MONTGOMERY COUNTY PLANNING BOARD
OPINION

Preliminary Plan No.: 1-87080
Name of Plan: Armenian Youth Center
Date of Hearing: July 27, 1995

Action: APPROVAL, subject to conditions. (Motion to approve made by Commissioner Aron, seconded by Commissioner Holmes, with a vote of 4-1. Commissioners Aron, Richardson, Baptiste, and Holmes voting in favor of the motion; Chairman Hussmann voting against the motion).

PRELIMINARY PLAN
 OF
 ARABIAN YOUTH CENTER
 OF
 GREATER WASHINGTON, INC.
 MONTGOMERY COUNTY, MARYLAND

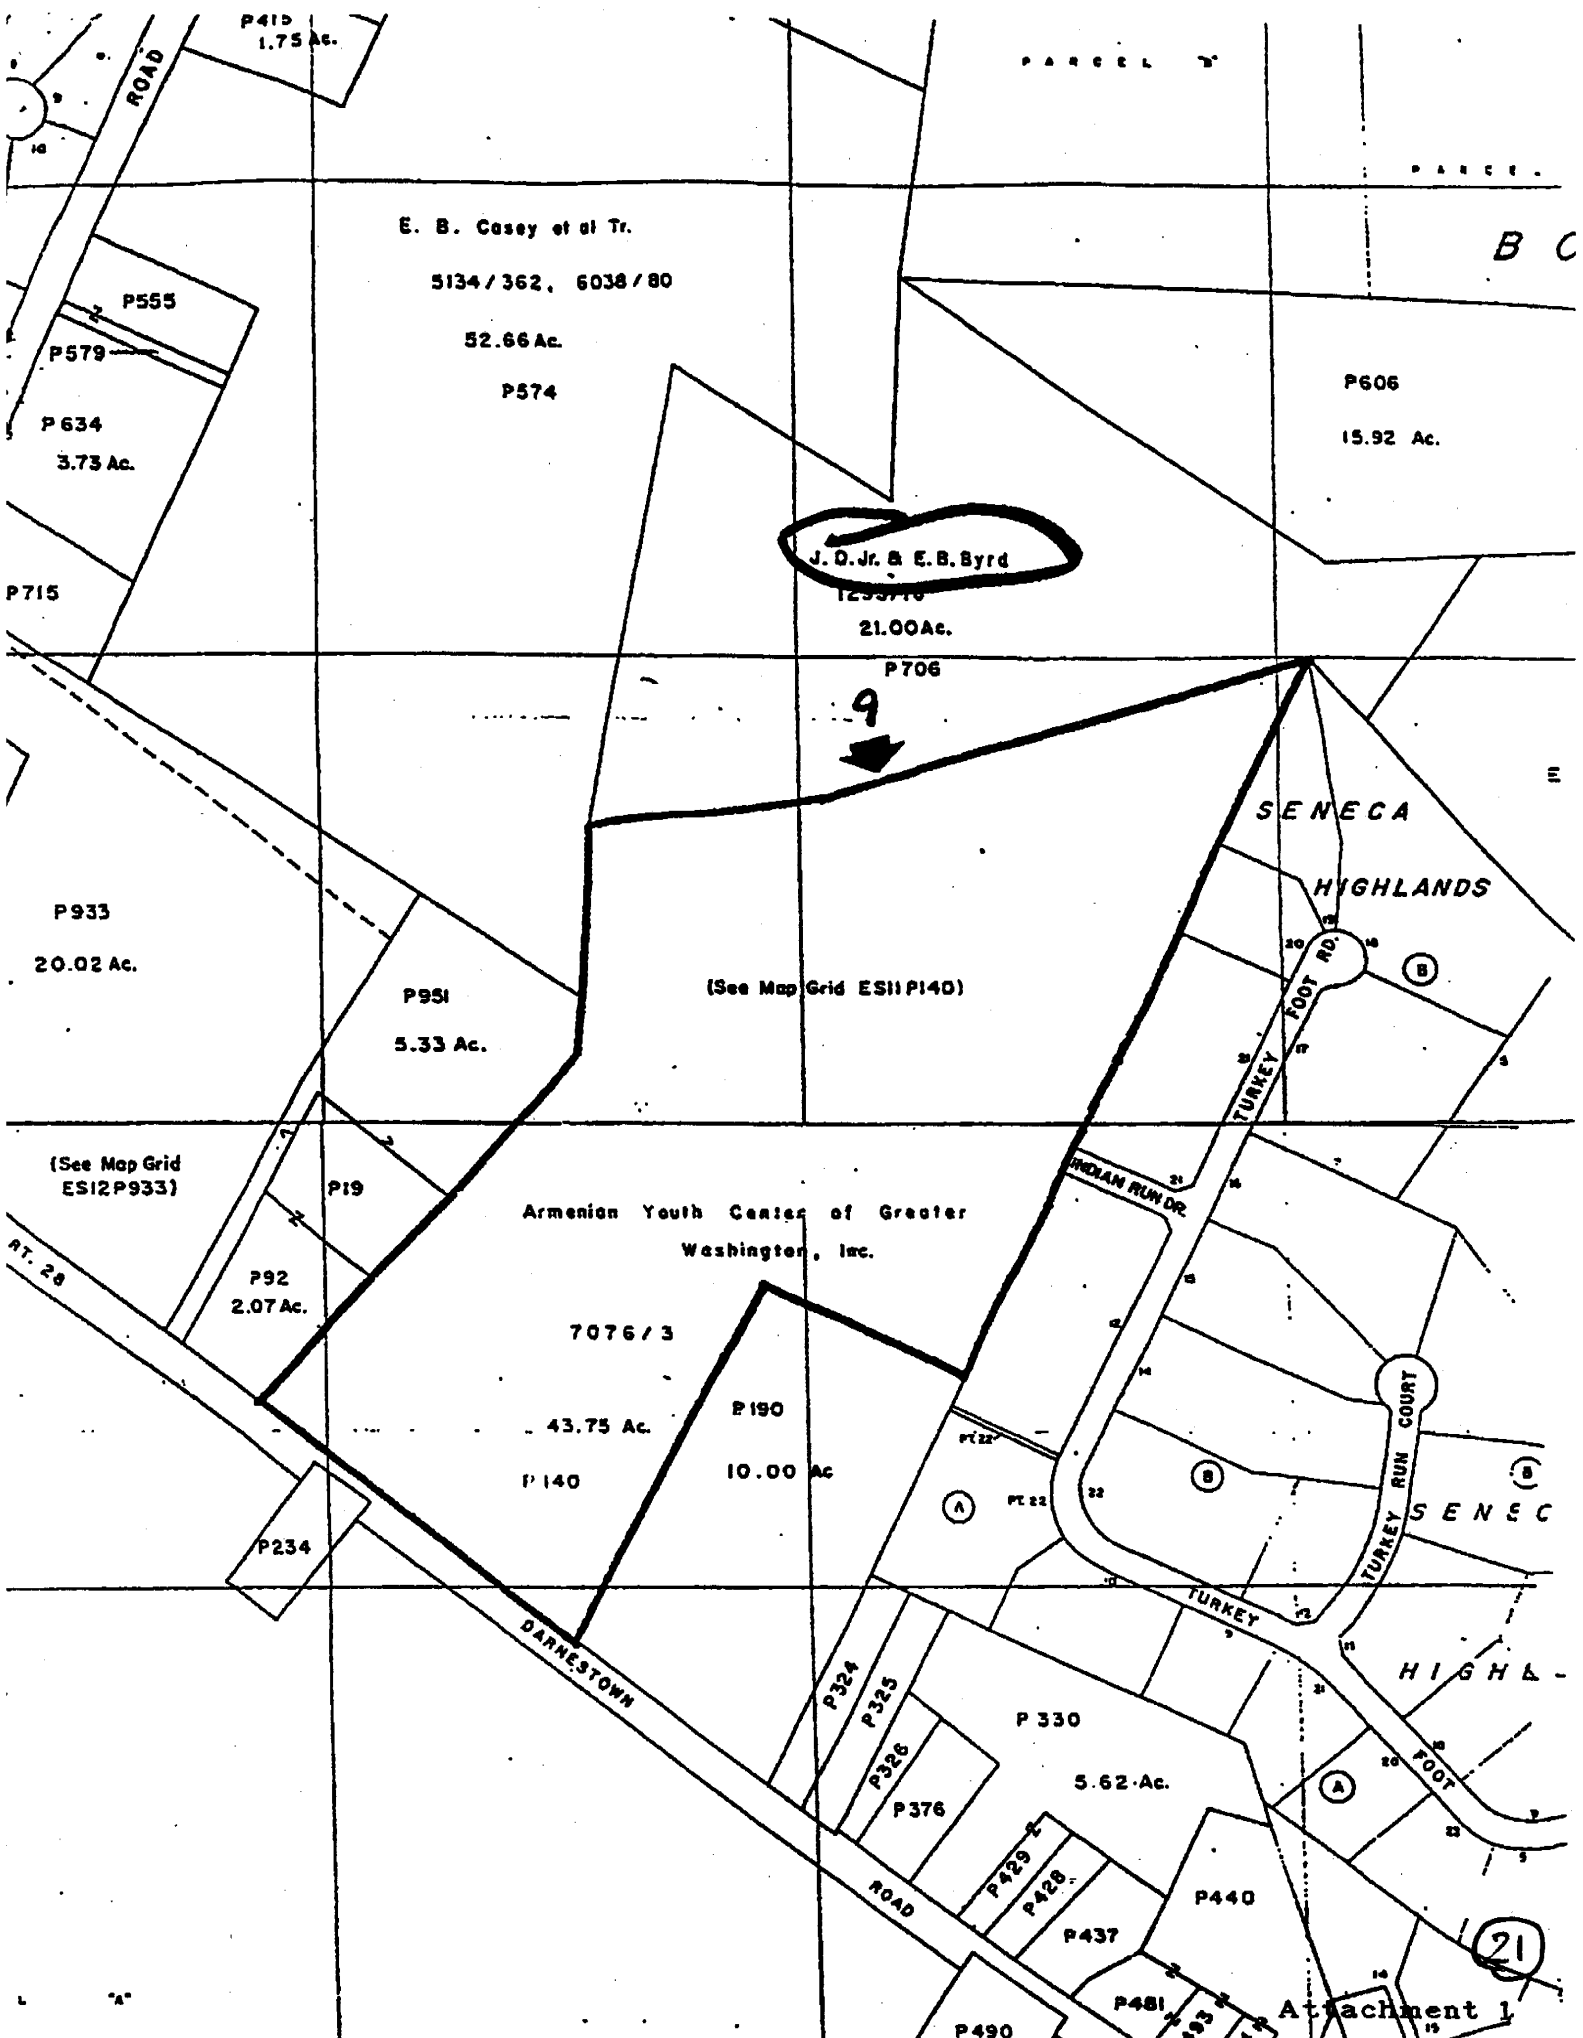
Adjacent property owners opposing this decision, Steven and Pamela Murray, through their attorney, Stanley Abrams, Esq., suggested that the preliminary plan does not comply with the purposes of the Rural Cluster Zone and that the proposed septic area for the church cannot be located on the church lot within the area designated open space area.

The proposed use of open space areas for septic system disposal on the church lot (Lot 107) is still contrary to the holding in the Brinklow decision in *GLP Development v. M-NCPPC* (unreported 7/31/90, by the Maryland Court of Special Appeals).

In the GLP decision, the Court affirmed the Planning Board denial of a subdivision plan, reflecting the placement of underground septic pipes on adjacent property in the Rural Cluster Zone, and found that such a use was not a permitted use in that zoning district to serve an adjacent commercially zoned property. The Murrays contend that in the current application submittal, the 18 acres of open space dedicated to the 6 residential lots, are dissimilar to the 9.08 acres that are delineated as open space for the church lot. The Murrays believe that the septic fields for the church occupy a substantial portion of the 9.08 open space acreage provided for Lot 107.

They suggested that not only is the open space associated with the church site not separately delineated, but that it still is being used to support septic system facilities. The Murrays believe that Sections 59-C-9.51 and 9.52 of the Montgomery County Code, preclude the placement of the church septic fields on the church open space.

In their second point of opposition, the Murrays contend that the open space area for the residential units must be conveyed to the homeowner's association--not merely "dedicated", as proposed by this preliminary plan.

The Murrays claim that the open space areas are not part of residential Lots 101-106, and therefore, a "dedication" should not be permissible. They assert that the purpose of requiring outright conveyance of open space to a homeowners or property owners association, as opposed to dedication, is to afford residential lot owners ownership and control over the common open space. Finally, they conclude that the only instance where something less than outright ownership is permitted is where the open space may be provided by easement on the residential lot so that the lot owner maintains control over the open space area.

The Murrays believe that the Applicant reduced it's proposed development in order to avoid the need to obtain from the Montgomery County Council an amendment of the Ten Year Sewer and Water Plan for installation of an 11,000 gallon per day septic system. They suggest that the Church has future, undisclosed plans for an additional free-standing community building.

The initial plan which showed the Phase 1 development as the Church, parish hall, ancillary office and classrooms. It showed Phase 2 as a "community building" for which there is no information on the current plan. The Murrays are particularly concerned that a future community building will be placed behind or along-side what is the proposed parking area on the current plan, in very close proximity to their common property line.

The Murrays are concerned that the current plan provides for a large stormwater management retention facility adjacent to their property, with what appears to be a release pipe from the pond directing water to their property. They believe that the stormwater management component of this plan has been conditionally approved by the Montgomery County Department of Environmental Protection, contingent upon their granting a permanent drainage easement. The Murrays have not been approached about granting such an easement, and are unwilling to do so. Given their refusal to grant the required permanent easement, the Murrays assert that the preliminary plan should only be approved with an independent stormwater management plan.

The Murrays assert that the plan for cluster development does not indicate an arrangement of residential development so as to reduce, as much as possible, any nuisance, jeopardy or conflict between uses with the tract and those in relation to adjoining or nearby property, particularly the Murrays' property in order to demonstrate compatibility with existing adjacent, and in close proximity, to the Murrays' property, when the placement could occur at more remote distances anywhere within the confines of this 43-acre parcel, reflects a failure of compliance with the Zoning Ordinance. The bulk of the development is, in the Murray's view, placed directly in front of the Murray's home, and their home will face into the proposed large building and parking area without separation by a public street, buffer or landscape separation.

Furthermore, the Murrays contend that the plan of cluster development, under Zoning Ordinance requirements, must show how scenic vistas are being preserved or enhanced, and reflect an arrangement which has considered the visual impact of the development on those vistas. They believe that the subject plan fails in this regard. They push that the scenic vistas of this property are not enhanced by the location of an extremely large sized building, close to the MD Rt. 28 frontage, which they state, if anything, blocks vistas of a large majority of this site. They claim that one does not obtain a feeling of open space with this type of building configuration.

The Murrays further suggest that the sitting of the church/parish all is solely related to gaining maximum visibility from MD Rt. 28, and has nothing to do with enhancing or preserving scenic vistas. Further, they believe that significant scenic vistas would be "lost, obliterated or substantially diminished in value due the cluster development" proposed here. They claim that this may not be the case if the resident component were "flipped" with the church lot so that the Murrays would be faced with compatible residential uses, as opposed to a large, intensely utilized facility such as proposed by the applicant.

Earlier versions of Preliminary Plan 1-87080 reflected church septic fields in residential open space. The applicant has modified the plan to show a single lot for the church and 6 residential lots. The church lot is 60% open space and utilizes its own space for its own septic fields. The residences will also have a homeowner's association to own and manage its separately calculated open space.

Condition 4 proposed by the Planning Staff, and adopted as a condition of this approval requires creation of a homeowners association with governing documents submitted and approved by the M-NCPPC. Notwithstanding, the creation of open space for purposes of the Rural Cluster zone is governed by Section 59-C-9.53(d) which permits recordation of open space as either:

However, the plan presented to the Board encompasses the entirety of the site. The conditions of approval proposed by the Planning staff, and adopted by the Board in this approval, require execution of an agreement between the Applicant and the M-NCPPC limiting development to a House of Worship and other uses as shown on the plan approved and described in the Applicant's July 21, 1995 traffic statement.

Currently, the Department of Environmental Protection's approval of the applicant's stormwater management plan requires a permanent drainage easement from the Murrays (which they do not wish to grant). This contingent stormwater management approval does not preclude the Board's regulatory approval of the preliminary plan, pursuant to Section 50-35. Assuming compliance with other regulatory requirements the Board has incorporated the Department of Environmental Protection contingency into the conditions of Planning Board approval. From a practical standpoint,

The Board finds that plan, as modified by the conditions imposed herein provides an arrangement of residential development that offers the maximum reasonable protection for the open space required under the zone. The vast undeveloped acreage of land, with its untouched natural foliage, that exist between the required open space and the Darnestown Local Park, sufficiently maintain the scenic vistas of this particular area. Due to the required open space, the dedicated land, and the preserved park, approximately, 26 of the 43 acres of land will remain intact and will be preserved in an undeveloped state.

The Board finds the development provides an arrangement of residential development that reduces, as much as possible any nuisance, jeopardy or conflict between the residential land and any on site and nearby agricultural uses and that the plan is compatible with existing development in this area. The plan provides for 6 new homes that blend easily into an existing neighborhood of similar character and zone. Placement of the homes as shown on the plan will allow the minimum clearing of trees, grading, stream disturbance or similar dislocations of the natural environment.

The citing the church as proposed, is a superior plan than what might be achieved by reversing the sites of the houses and the church. In the presently proposed location, the church meets the Board's preference of giving the church parishioners access to MD Rt. 28, rather than encouraging traffic to drive through the existing neighborhood. There is approximately 150 feet between the church and MD Rt. 28, which gives the site a recessed placement, thus adding to beneficial arrangement of this plan.

As discussed above, the plan provides the open space for both the church lots and the residential lots. The open space for the residential lots will be deeded to a newly created homeowners association.

There is approximately 2,250 feet of open space and parkland between the driveway to the church off MD Rt. 28, and the MD Rt. 28 and Seneca Road intersection. The Board finds that this open land will sufficiently maintain the scenic vistas, and that the requirement of the 60% open space,

- (1) Prior to the recording of plats, the Applicant must enter into an agreement with the Planning Board to limit development to a House of Worship and associated uses as outlined in the applicant's traffic statement dated July 21, 1995.

- (3) Revise the residential open space delineated on preliminary plan to delete the 30' panhandle proposed along the northwest property line of the House of Worship lot (Lot 107). This area should be incorporated into Lot 107.

- (4) Record plat to reference the 18-acre open space parcel associated with the 6 residential lots. Parcel is to be conveyed to the Homeowner's Association (HOA). The HOA documents must be submitted technical staff review and approval prior to recording of plats.

- (5) Delineate area encompassing the 60% open space required for Lot 107.
- (6) Provide minimum 30' wide landscaped buffer strip along the northwest property line to provide a wooded buffer between House of Worship and adjacent residential developments.

- (7) Prior to recording of plats, submit for technical staff approval a landscape and lighting plan to provide buffers as outlined in condition #5 and screening along Darnestown Road (MD Rt. 28).

- (8) Dedication of an area of approximately 2.4 acres for future expansion of the Darnestown Local Park. Technical Staff approval of exact area and location prior to recording of plats.

- (9) Record plat to reflect delineation of a conservation easement over the areas of tree preservation and afforestation.
- (10) Access and improvements as required and approved by MDSHA.

- (11) Conditions of MCDEP stormwater management approval dated February 8, 1995. If the condition for drainage easement cannot be implemented, then prior to record plat, applicant must secure MCDEP approval of a revised concept that utilizes on site quantity and quality control, and removes the need for an easement on the adjacent property.

- (12) Conditions of Health Department approval dated June 16, 1995 and reaffirmed July 16, 1995.
- (13) Dedication of Darnestown Road (MD Rt. 28) 60' off center line and provide 60' right-of-way and termination of Indian Run Drive.

- (14) Other necessary easements.
- (15) Applicant to provide an ingress/egress easement to accommodate future access for Parcel (706). The location and width of this easement (and any related (PUE)) must be finalized prior to record plat submission and must be shown on the plat.
